ADDENDUM 1

Subject: BID# 13-063, El Paso County Colonia Revolucion Water System Improvement Project Storage and Pump Station Facilities

FROM: PARKHILL, SMITH & COOPER, INC.

PROJECT NO.: 01.5005.11

CT-201R

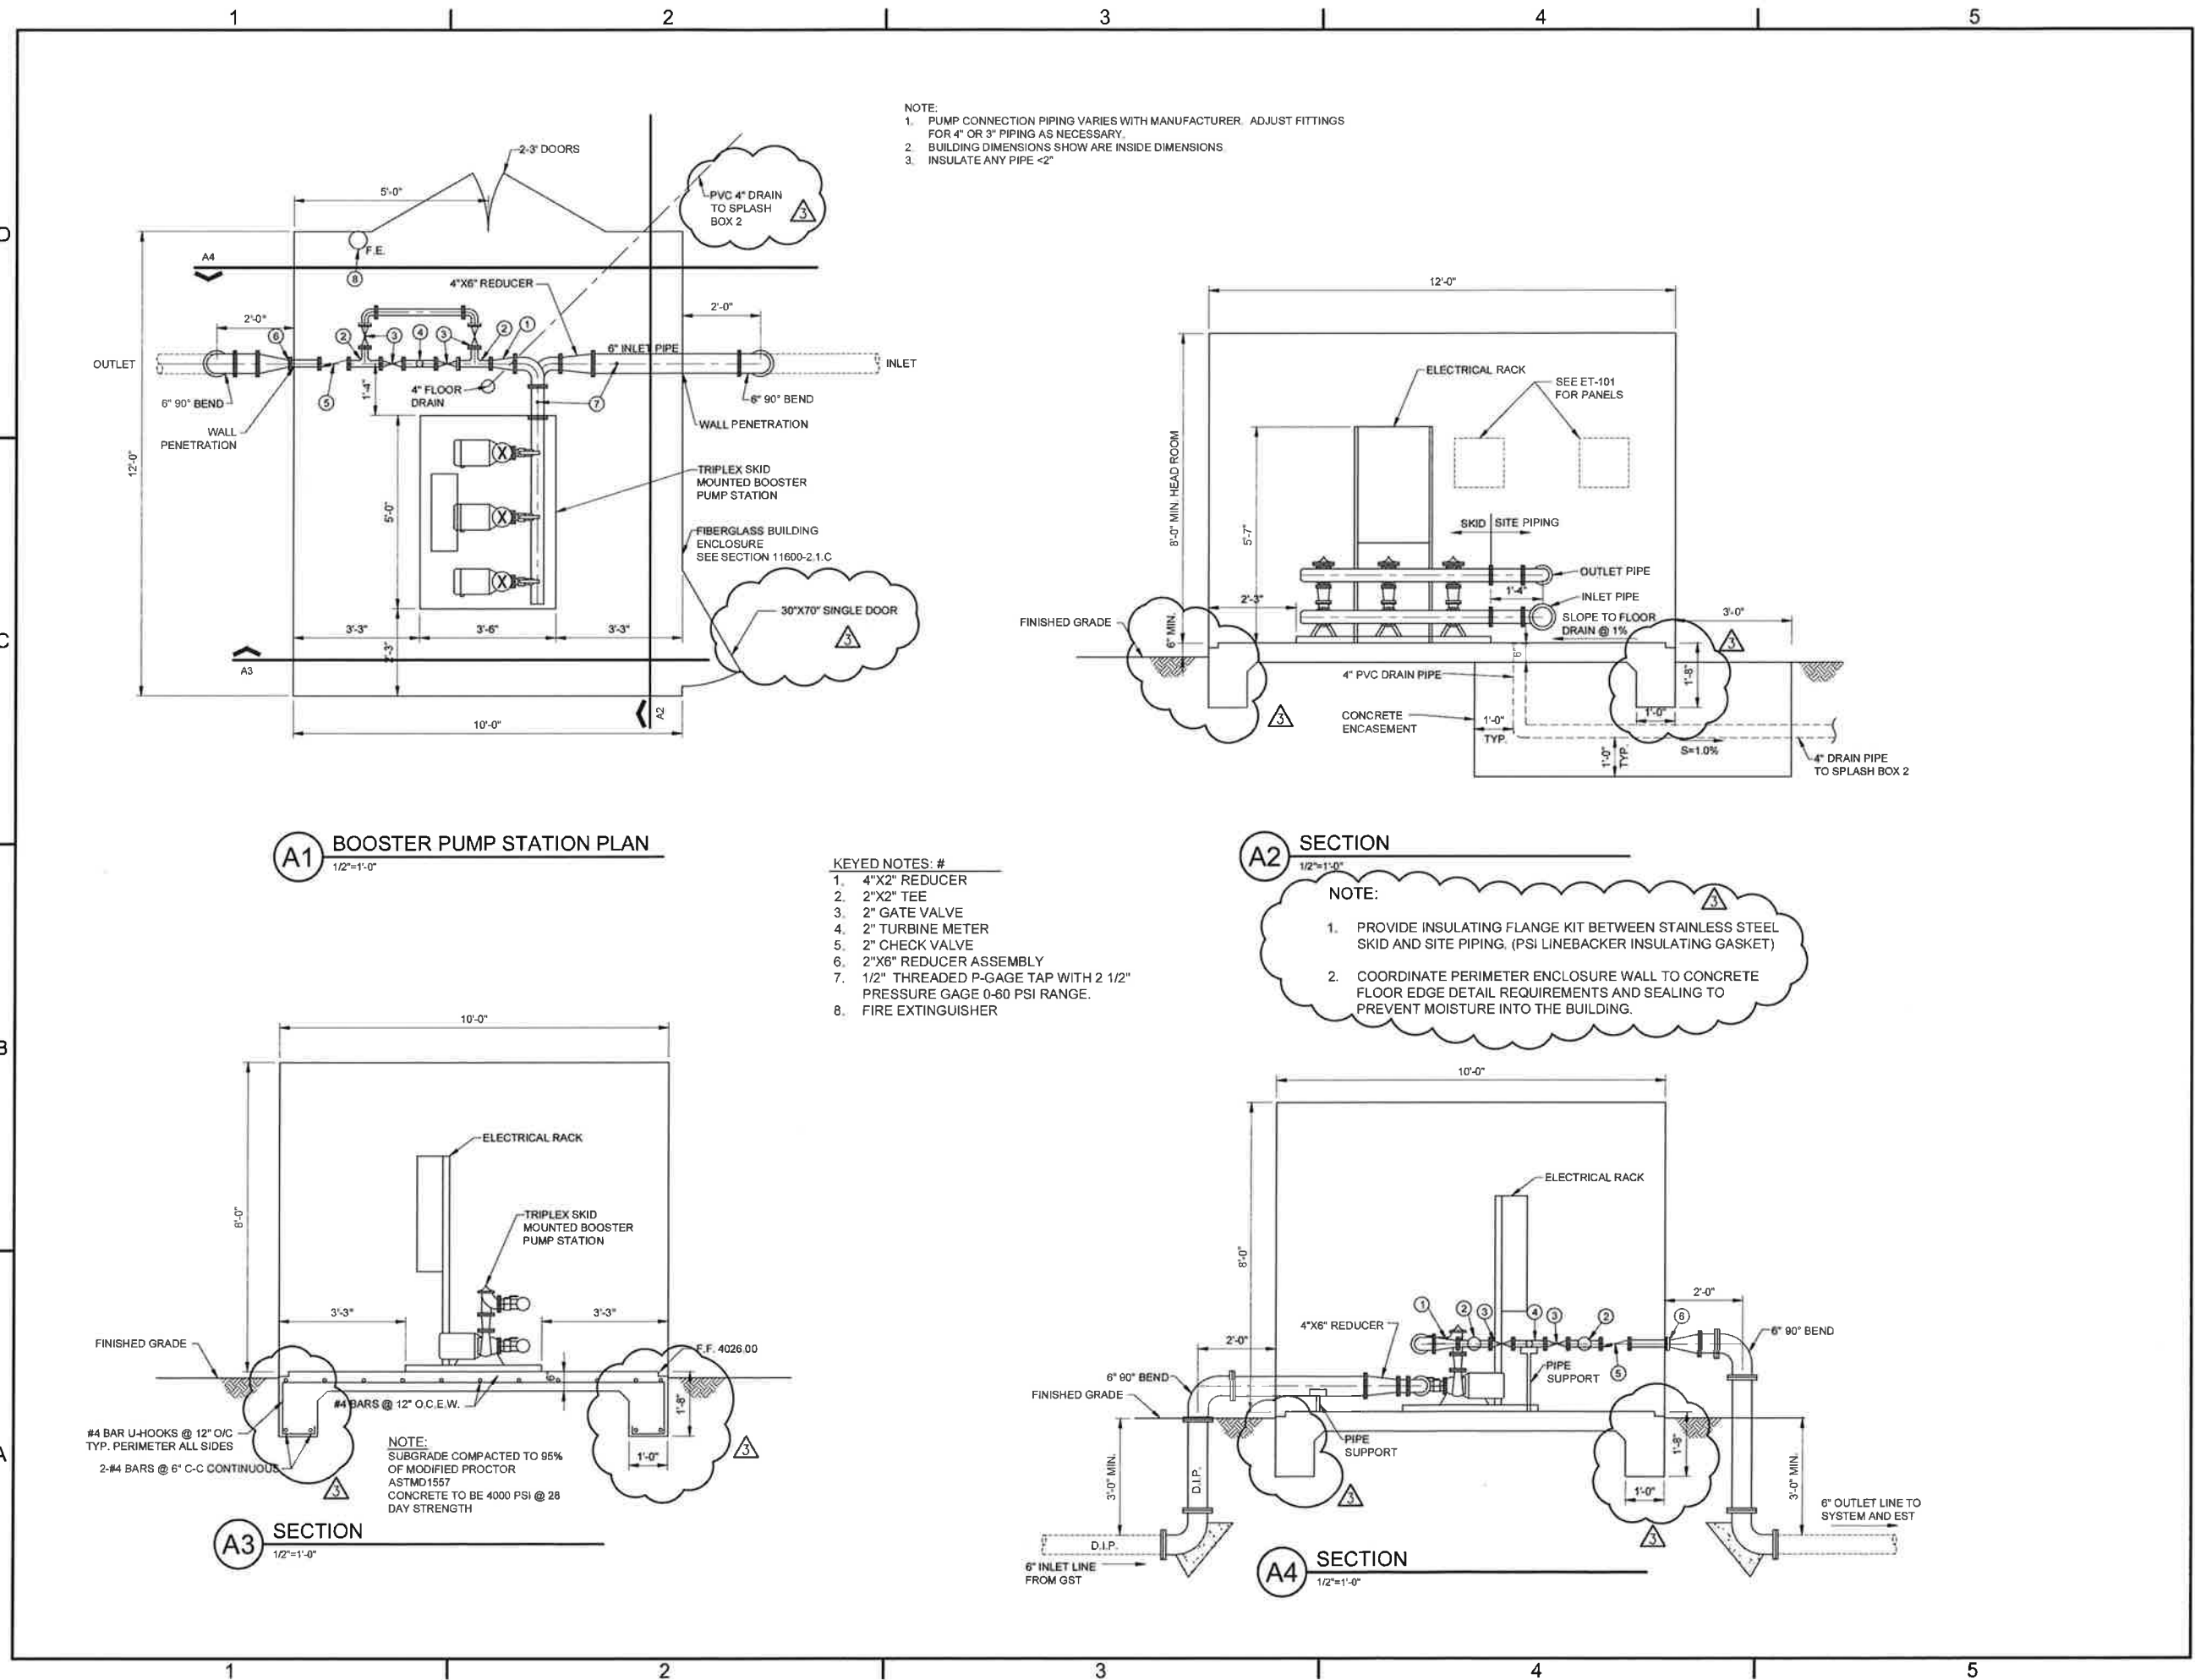
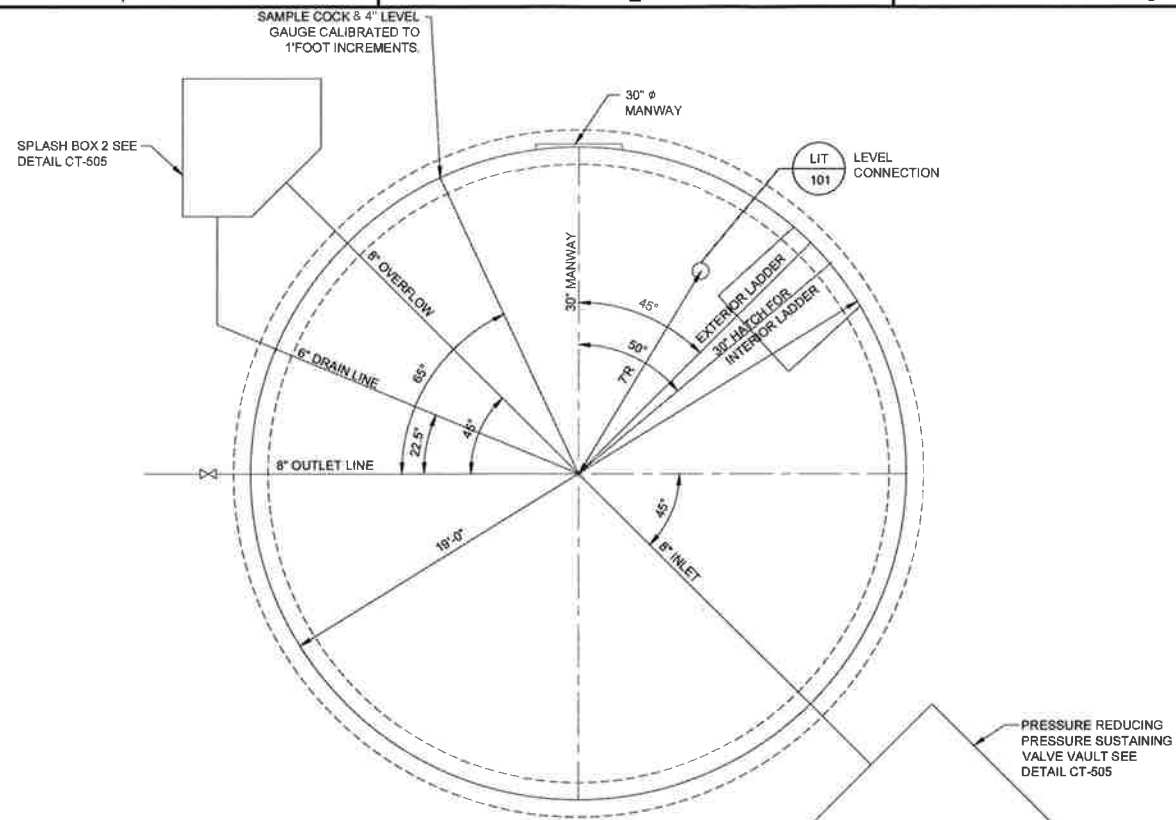
1. PROVIDE INSULATING FLANGE KIT BETWEEN STAINLESS STEEL SKID AND SITE PIPING. (PSI LINEBACKER INSULATING GASKET)
2. COORDINATE PERIMETER ENCLOSURE WALL TO CONCRETE FLOOR EDGE DETAIL REQUIREMENTS AND SEALING TO PREVENT MOISTURE INTO THE BUILDING.
